**Technical Comments of the Cities of  
Augusta, Georgia and North Augusta, South Carolina  
on**

***U.S. Army Corps of Engineers Report:  
“Savannah Harbor Expansion Project,  
Georgia and South Carolina: Fish Passage at New Savannah  
Bluff Lock and Dam  
Integrated Post Authorization Analysis Report and  
Supplemental Environmental Assessment”  
and Related Documents***

**Augusta, Georgia**

**North Augusta, South Carolina**

*Figure 4: Underwater jetty protruding through water surface following river level drawdown.*

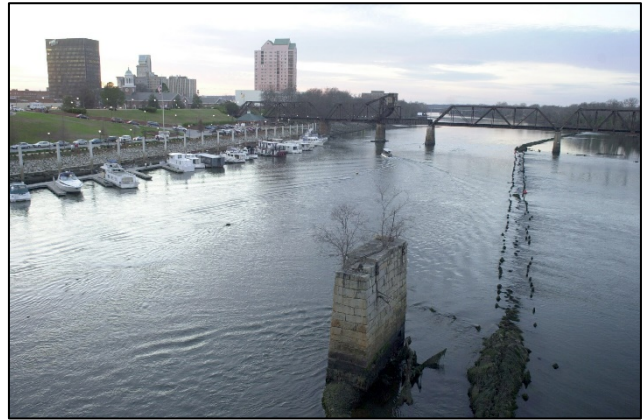
As for navigability within the pool, the lowered water levels of all of the Option (ii) choices will impair or prevent safe navigation of several reaches of the pool. The recommended plan is particularly onerous, in that it purports to keep the functionality of the pool, yet dangerously exposes boat traffic to underwater obstructions that heretofore have not come into play. A particular safety issue would be newly created along the structure known as Gardner’s Bar training wall or jetty, which extends for about one

mile down the middle of the river near the centers of the two cities. It was constructed by the Corps of Engineers prior to 1915 to divert the main flow of the river to the Georgia side to keep the docks at Augusta scoured out to prevent shoaling. This wall is constructed of timber piles, cribs, and rock. At the existing water levels this training wall is not a major impediment to navigation and recreational use, but at lower stages of the pool the wall becomes a hazard to navigation and at the lowest level it even protrudes from the surface of the water. It will effectively narrow the useable width of the river to about half its present width, right in the middle of town where boat traffic is the greatest and where water sporting events have regularly occurred. If water levels are to be lowered, the Corps should include in the project mitigation measures for the wall not merely by “avoidance,” as stated in the Draft Report<sup>12</sup>, including selective demolition to lower the top elevation so that vessels might safely pass over in the future, as well as allowances in the project costs.

Figure 6

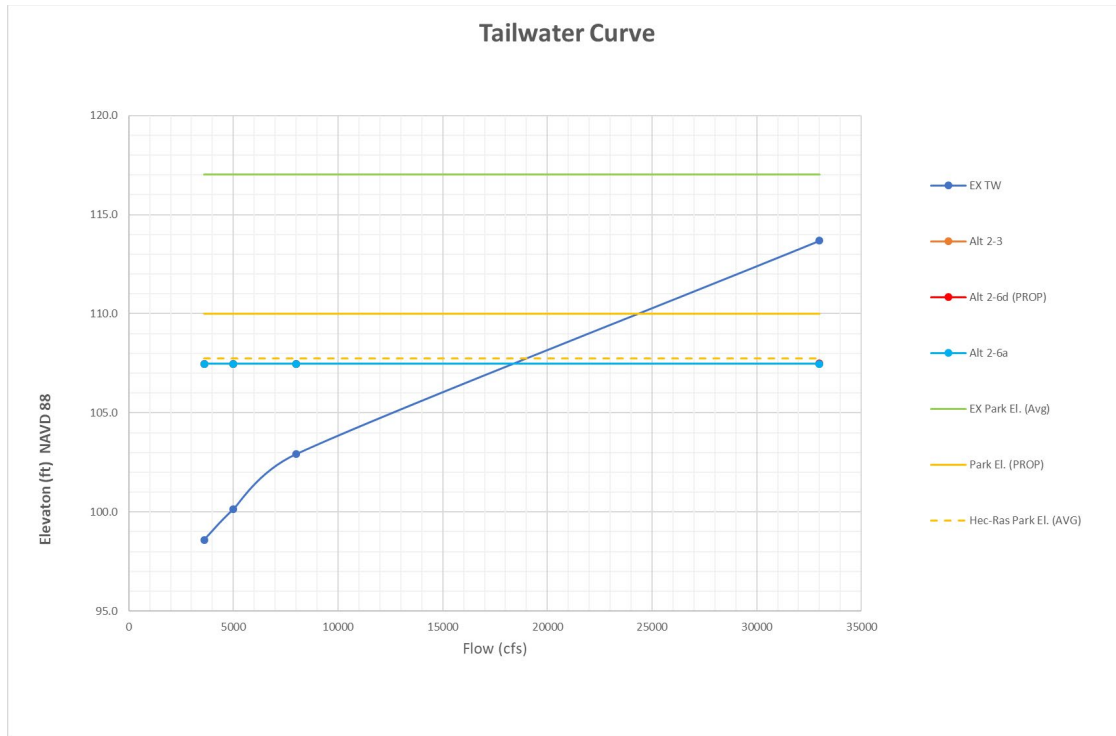
- b. Flooding from the downstream river commonly referred to as “tailwater” or “backwater.” The Figure entitled Tailwater, below, is based upon the hydraulic modeling by the Corps. The Draft Report states that the floodplain bench would be lowered to elevation 110, however inspection of the HEC-RAS model indicates a much lower elevation of the bench of about 107.7. The existing elevation of the Park is about 117, which corresponds to a flow of over 35,000 cfs or about 0.5% of the time. The 110 elevation corresponds to a flow of about 24,500 cfs and a frequency of about 4% of the time. The 107.7 park elevation (from the model) occurs at a flow of about 18,500 or 8.5% of the time.

The difference in the elevation of the floodplain bench stated in the Draft Report of 110 and the modeled bench elevation of 107.7 is a significant discrepancy which would impact the development and evaluation of alternatives that account for impacts to this Park.

Figure 9: Dissolved oxygen percent saturation statistics from multiple continuous Savannah River water quality stations from January 2006 through January 2008 (from Comprehensive Savannah River Study, Final Report: February 2006-January 2008. Phinizy Center for Water Sciences.)

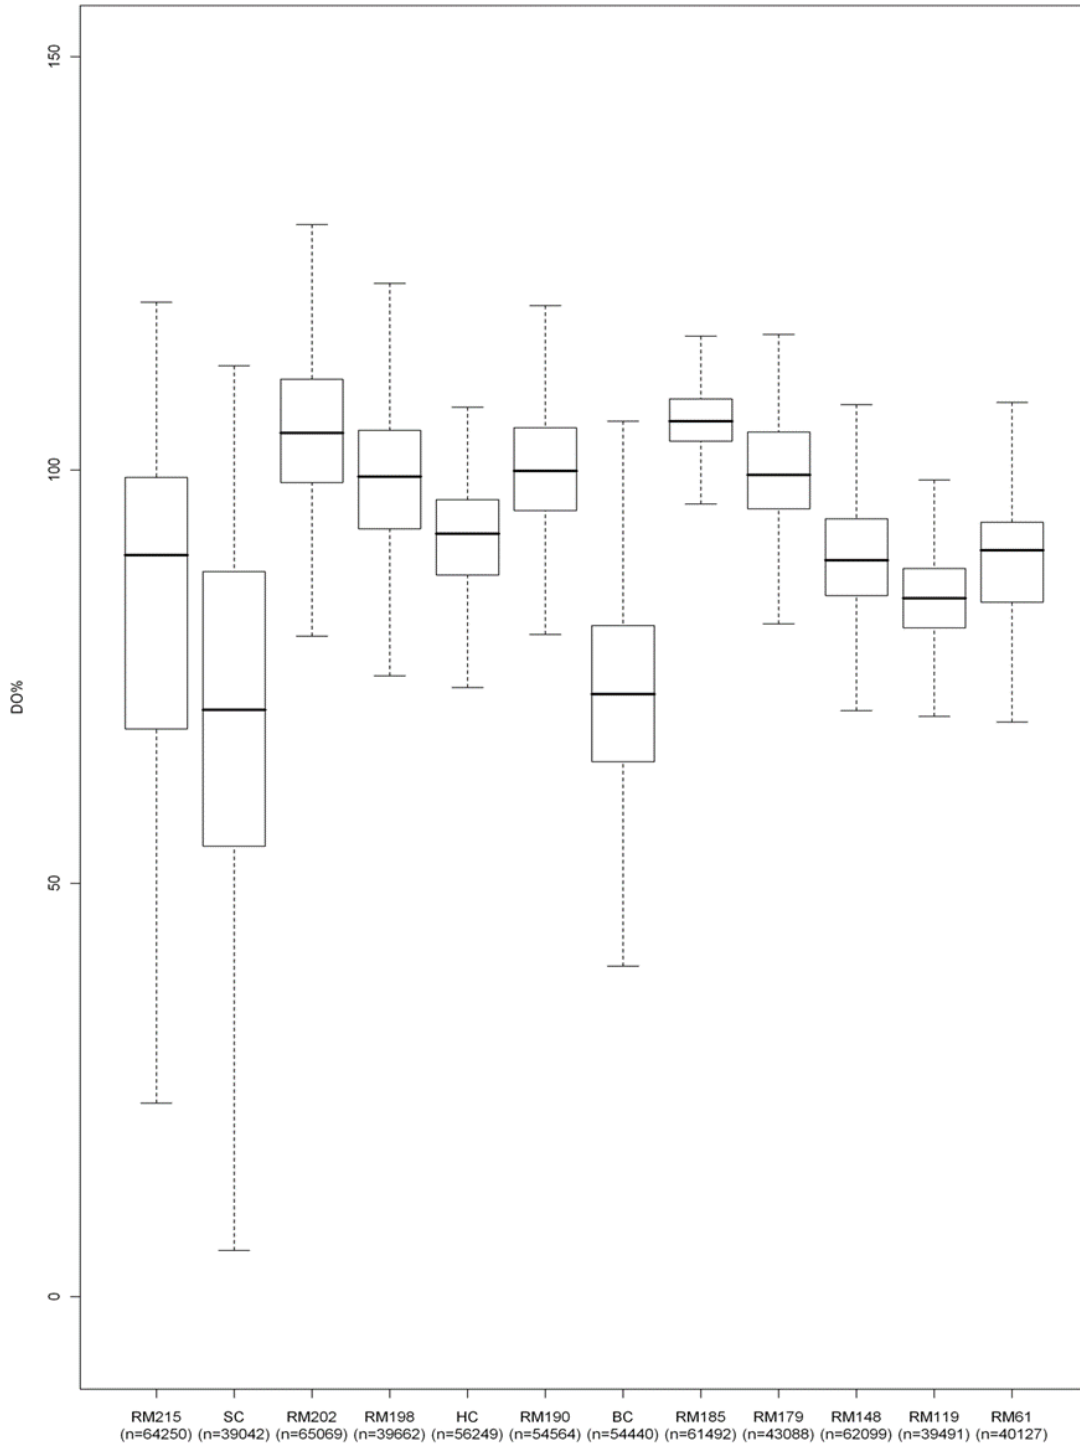
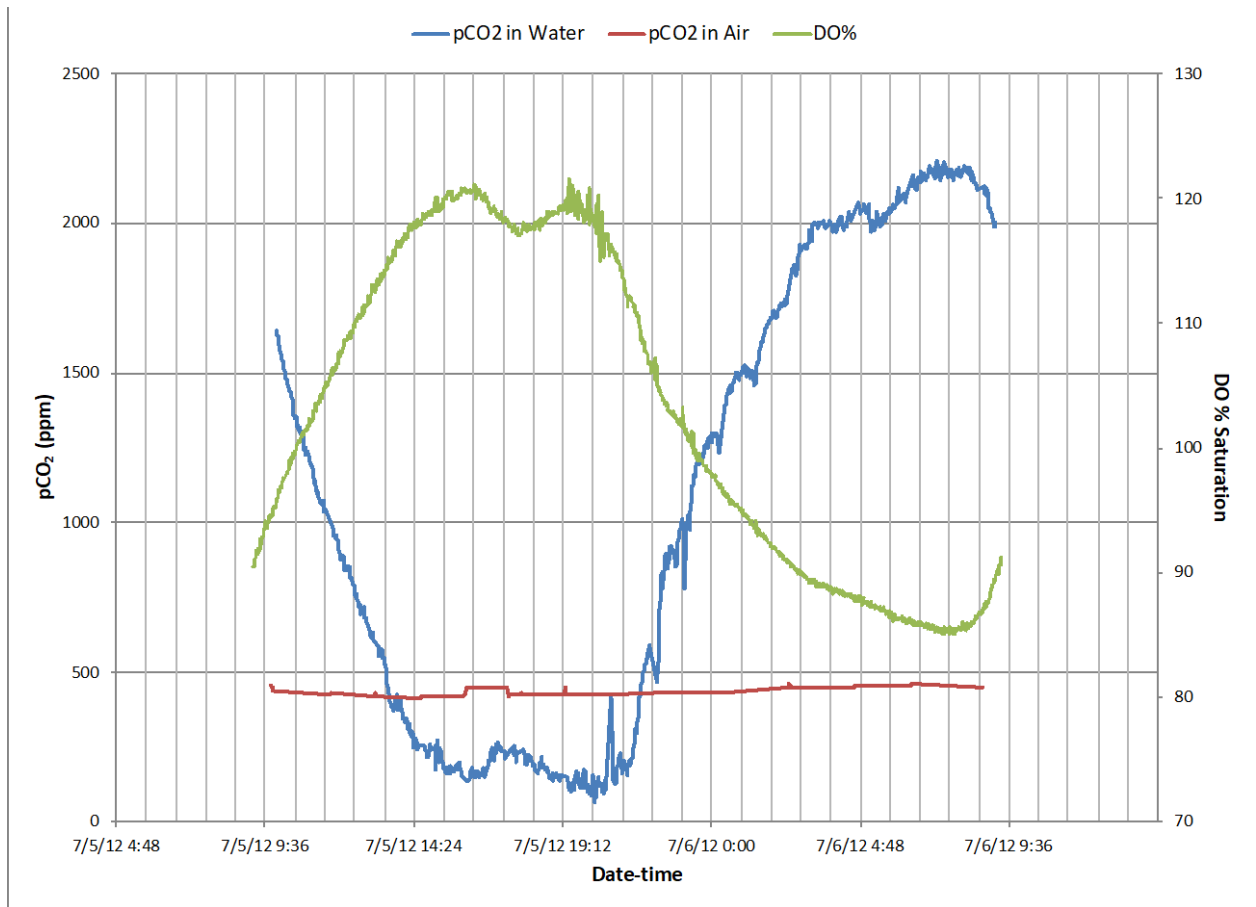
Since dissolved oxygen is so critical, there should be peer reviewed documentation from other rock ramp projects around the country that show dissolved oxygen dynamics will not be impacted by the chosen alternative. Furthermore, that documentation should be in the form of measured data from those projects and not modeled results since this impact is so critical to restoring the river and could impact the viability of each municipal and industrial discharger below Thurmond Dam.

Figure 2  
Non-Exceedance Curve from Draft Report

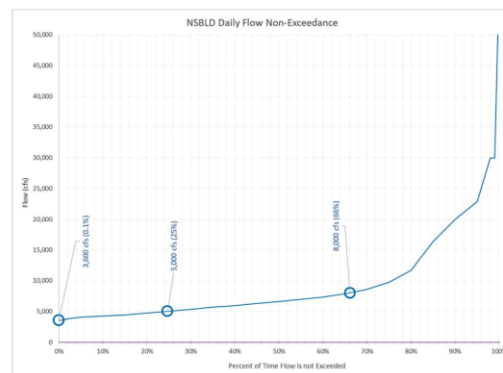
The Draft Report often references and reports pool elevations based upon a normal flow rate of 5,000 cfs. From the Draft Report: *"The flow used to evaluate the project impacts, with the exception of impacts to water supply intakes, is 5,000 cfs, the low average of the normal flow."* It is not clear why this flow rate was selected and we are not aware of a definition for *"the low average of the normal flow"*. However, flows lower than this occur over 25% of the time. This can be observed on Figure 7 of the Draft Report. **One-quarter of the time is very significant.** It can also be observed on this figure that the curve is quite "flat" from 3,600 (0.1%) to 8,000 cfs (66%). This again indicates that flows within this range occur much (66%) of the time and that there is a steep drop-off after 3,600 cfs.

Figure 4 -Pool Elevations Upstream of the NSBLD – as Provided in Table 8 of the Appendix A of the Draft Report

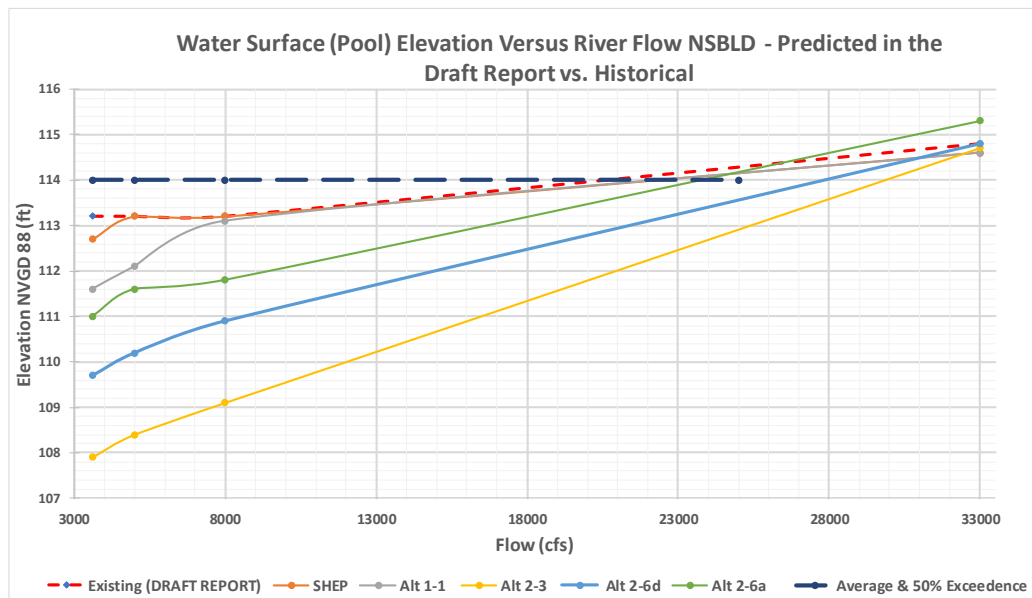
Pool elevations for the various alternatives including the SHEP are shown below in Figure 3 and were provided in Table 8 on page A-41 and A-42 of Appendix A of the Draft Report. Some results of various alternatives are plotted in Figure 4.

*Figure 5*  
*Crest Section of the Rock Ramp (Alternative 2-6d)*

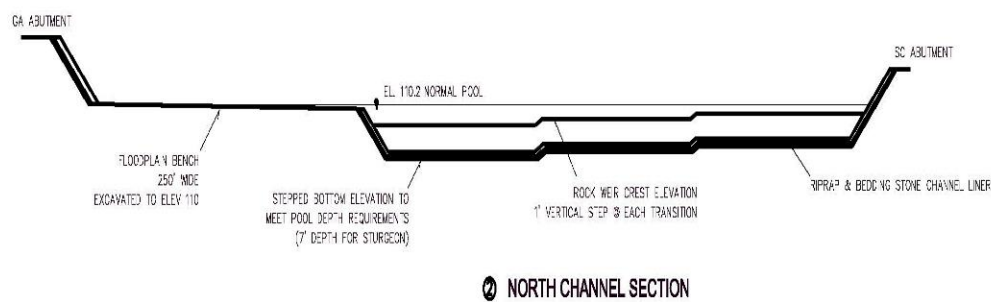
Review of the modeling that is used to predicted water surface elevations just upstream of the NSBLD for the alternatives was not reviewed in detail. At the proposed grade of 2% and the roughness coefficients provided, it is likely that the flow will be in a supercritical state, or at least go through critical depth at the crest of the rock ramp. Therefore, of primary concern is the configuration of the crest of the rock ramp. Figure 5 is a cross-section of the rock ramp fish passage of alternative 2-6d from the Draft Report. All the rock ramps in the various alternatives with rock ramps appear to be of a similar configuration.

*Figure 6  
Velocity Output Figure of Alternative 2-6d at 8,000 cfs*

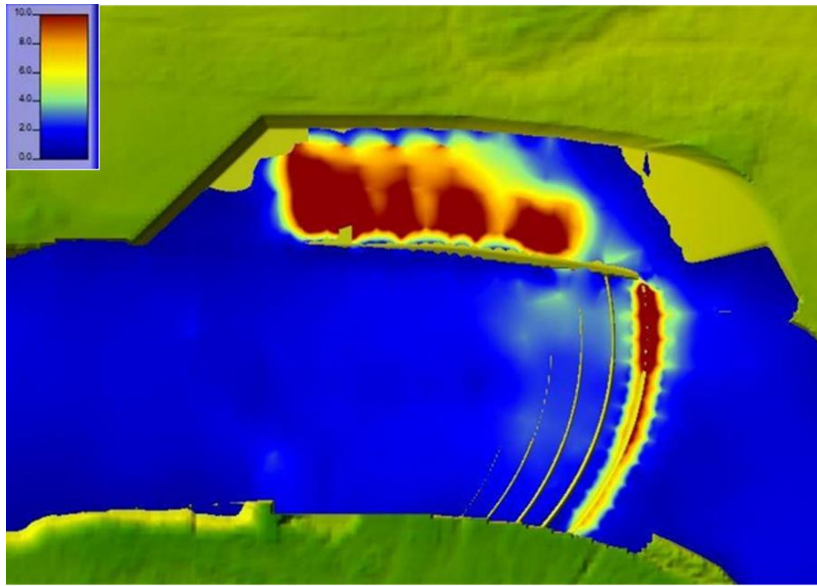
Figure 6 is a velocity output of the HEC-RAS model for Alternative 2-6d. The model provides estimation of the crest accurately because the geometry of the crest has a substantial impact on the water surface elevations predicted for the various alternatives with a rock ramp.

*Adaptations to the crests of the alternatives with a full-river width rock ramp may be necessary to create effective passage of target fish species. These adaptations are likely to require changes in the alternatives, lower upstream pool elevations more than currently predicted, cause other impacts, and ultimately influence a well-informed selection process.*

Figure 9  
Comparison of Observed and Predicted Pool Elevations at 5<sup>th</sup> Street

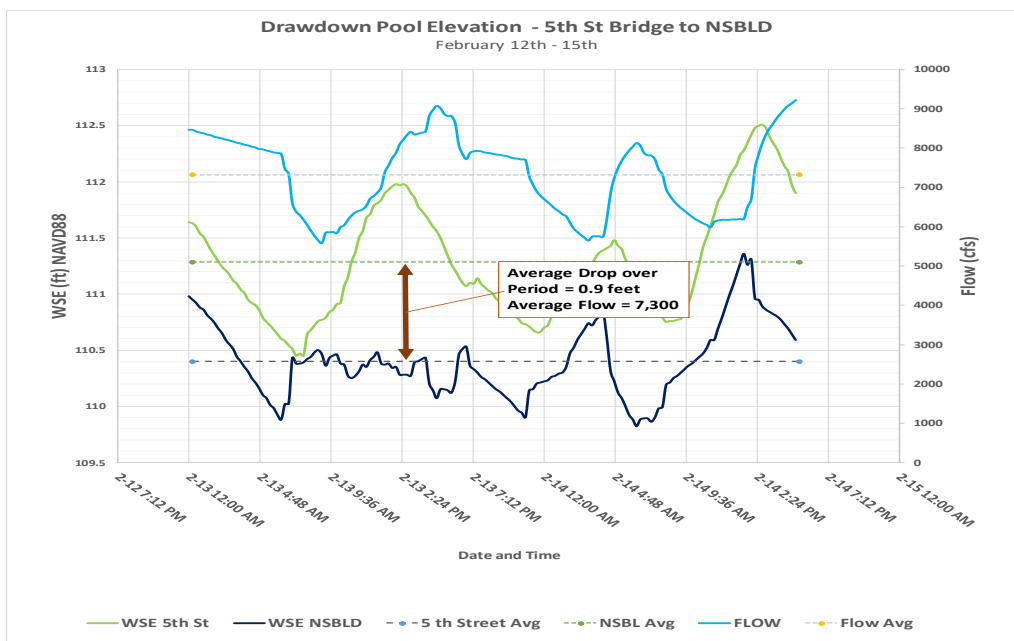
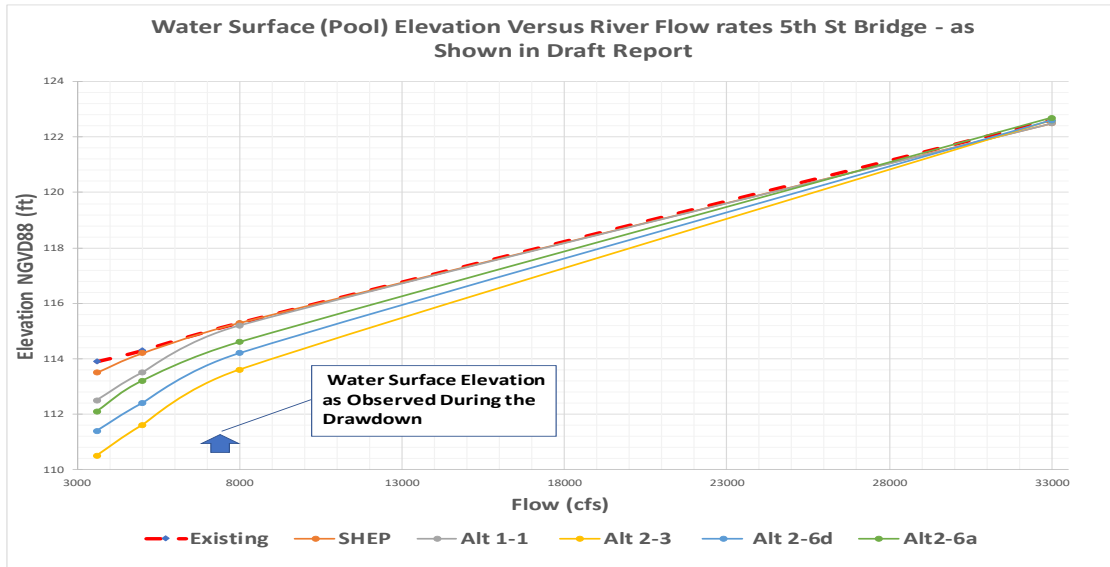
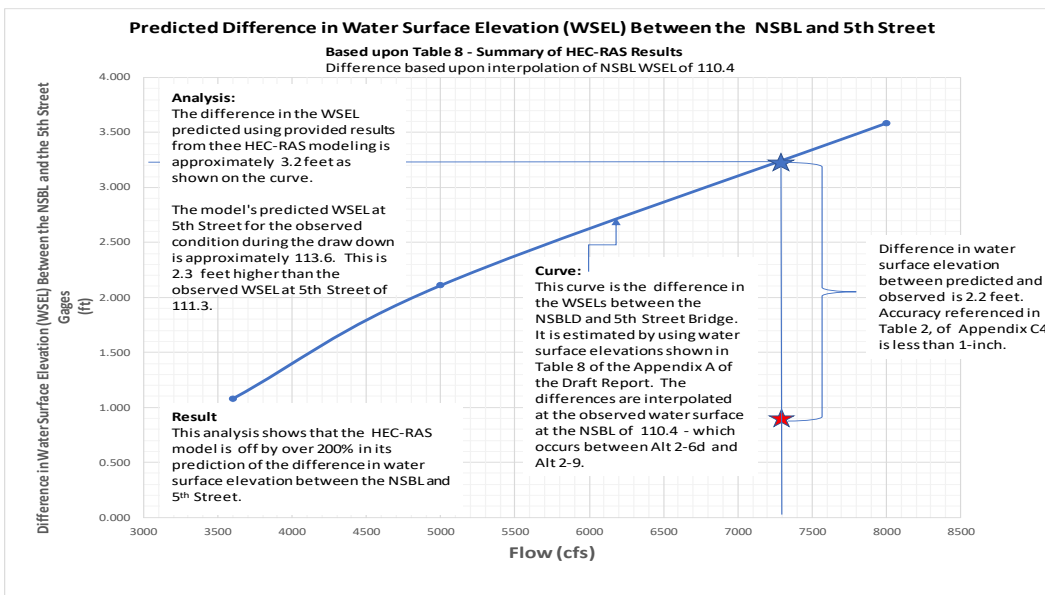
The average flow during this period was about 7,300 cfs. The average pool elevation just upstream of the NSBLD was 110.4 (NAVD88) and the average elevation was 111.3 (NAVD88) at the 5<sup>th</sup> Street Bridge. These flows and surface water elevations are shown on Figure 7.

In reviewing and comparing Figures 7, 8, and 9, it can be concluded that the elevations observed during the drawdown in the Pool at 5<sup>th</sup> Street are significantly lower than those predicted by the hydraulic model and presented in the Draft Report. The difference in water surface elevations between the gage just upstream of the NSBLD and that at 5<sup>th</sup> Street, is a practical and useful parameter in the evaluation of the accuracy of the HEC-RAS hydraulic modeling conducted by the USACE. The model predicted over three feet of difference in the water surface elevation between the gages, whereas the observed difference as estimated herein is less than one foot.
